REQUEST FOR TENDER WS-RFT-25-061
General Contracting Services for New Fire and Paramedics Response Station

The Corporation of the Town of Whitchurch-Stouffville
Community Services Department

ADDENDUM # 1

GENERAL NOTES - PAVEMENT

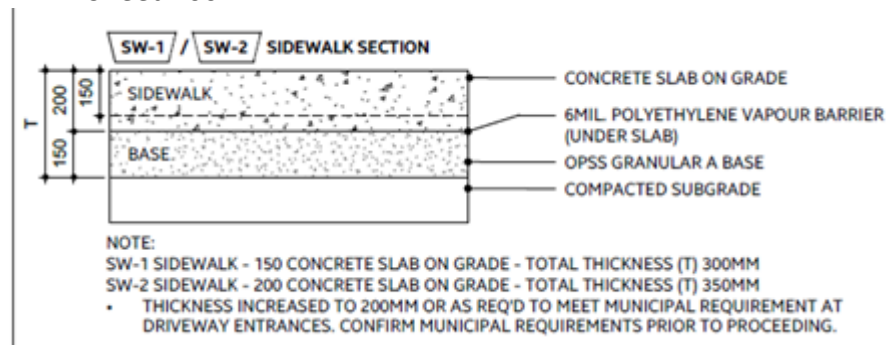
- a. Please confirm Light Duty paving is only required at the parking stalls.
- b. See below image. Please confirm we are to follow the Light Duty & Heavy Duty Pavement Profiles noted on the “General Notes – Pavement” section on Sheet 100, Notes & Details Plan.

- a. **There is no Light Duty Asphalt in the project. Heavy Duty Asphalt shall be used at the parking stalls.**
- b. **For the purposes of this RFT, follow the pavement profiles noted General Notes – Pavement section on Sheet 100m, Notes & Details Plan. Also refer to pavement profiles as referenced in the Geotechnical Investigation Report dated July 26, 2024 issued as part of this Addendum. Also refer to Drawing A002 – Assemblies and Notes bearing revision Number 25 issued as part of this Addendum. The pavement profiles in these documents has been revised to be consistent with Sheet 100, Notes & Details Plan.**

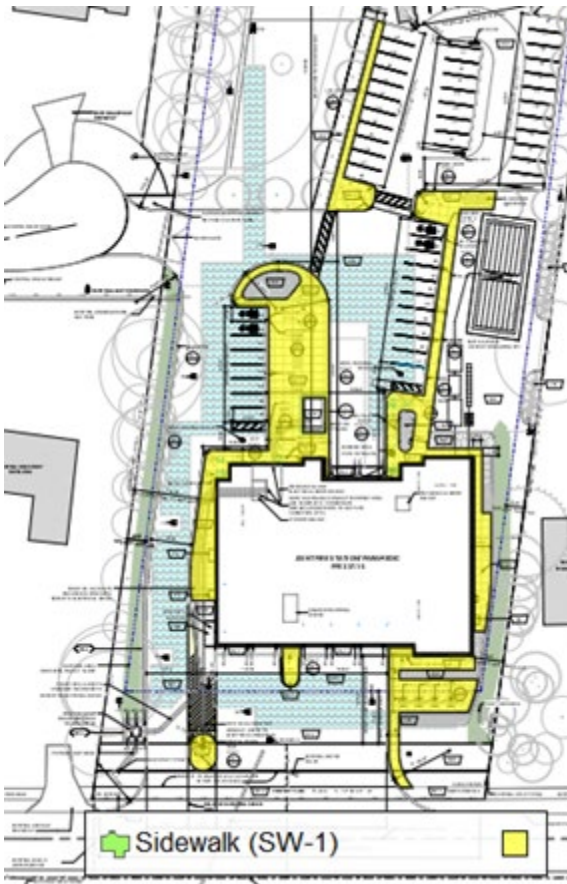
- h. Please confirm we are to follow the SW-1 & SW-2 sidewalk profiles noted on Sheet A002.

- h. **For the purposes of this RFT, the sidewalk profiles SW-1 and SW-2 noted on Drawing A002 bearing revision Number 25 shall govern (issued as part of this Addendum).**

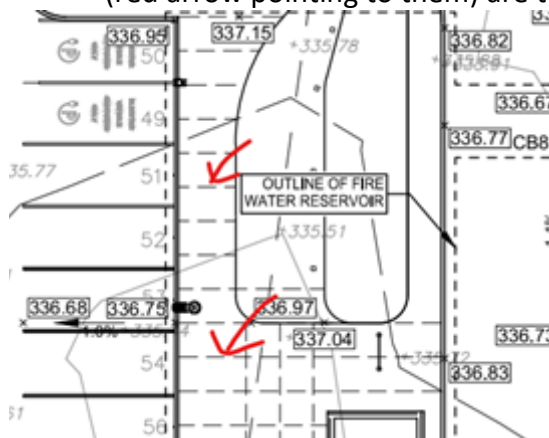
- i. Please confirm if we are to follow the Site Plan for the extents of sidewalk as it differs to what's shown on the Grading Plan.

- i. **For the purposes of this RFT, the sidewalk extents noted on Drawing A103 bearing revision Number 25 shall govern (issued as part of this Addendum).**

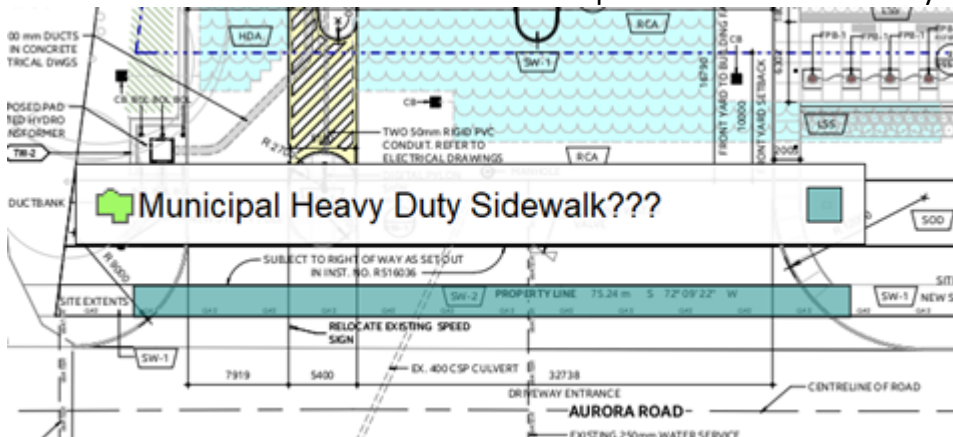
- j. Refer to below image. On the Grading plan, please confirm what the dashed lines (red arrow pointing to them) are to represent?

- j. **The dashed lines on the grading plan are a graphic representation of saw cuts in SW-1 sidewalks.
Refer to Drawing A103 bearing revision Number 25 issued as part of this Addendum which provides additional clarification of SW-1 extents.**

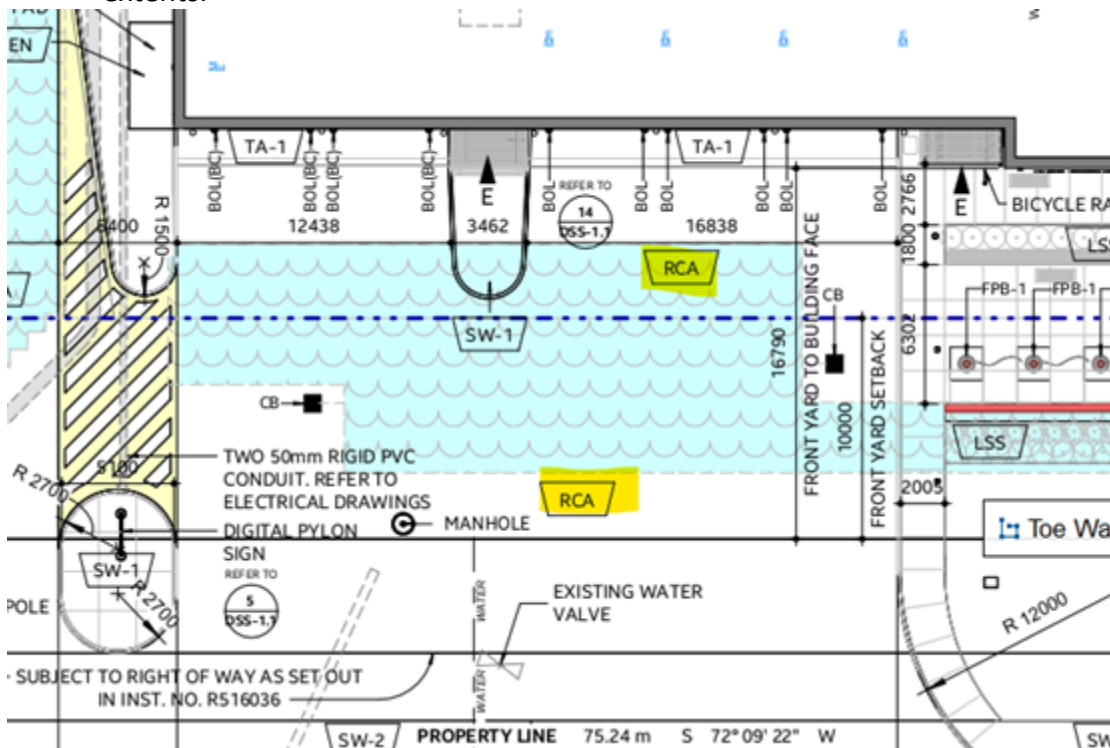
k. Please confirm if a new sidewalk is required across the driveway entrance?

- k. A new sidewalk is required across the entrance. It is noted as SW-2. Refer to Drawing A103 bearing revision Number 25 issued as part of this Addendum which provides additional clarification of SW-2 extents.
- l. A reinforced concrete apron (RCA) is required across the front of the apparatus and vehicle bays. It is noted as RCA. Refer to Drawing A103 bearing revision Number 25 issued as part of this Addendum which provides additional clarification of RCA extents.
- m. Response to be issued under subsequent Addendum.

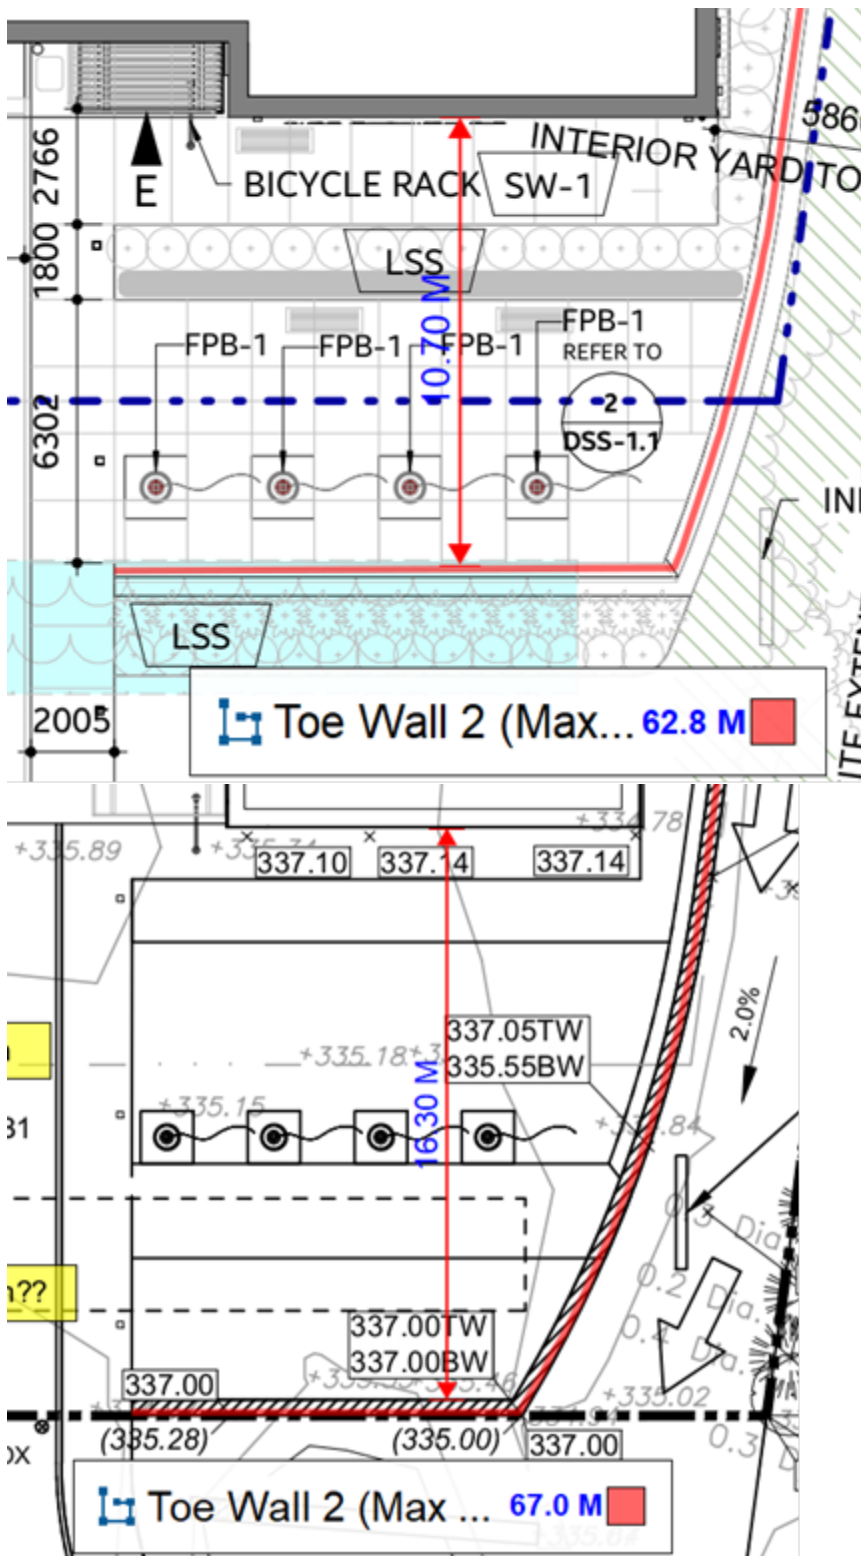
- I. Additionally, the Site Plan calls for a “reinforced concrete apron” (“RCA”) at the front of the building however the extents are unclear. Please confirm the extents.
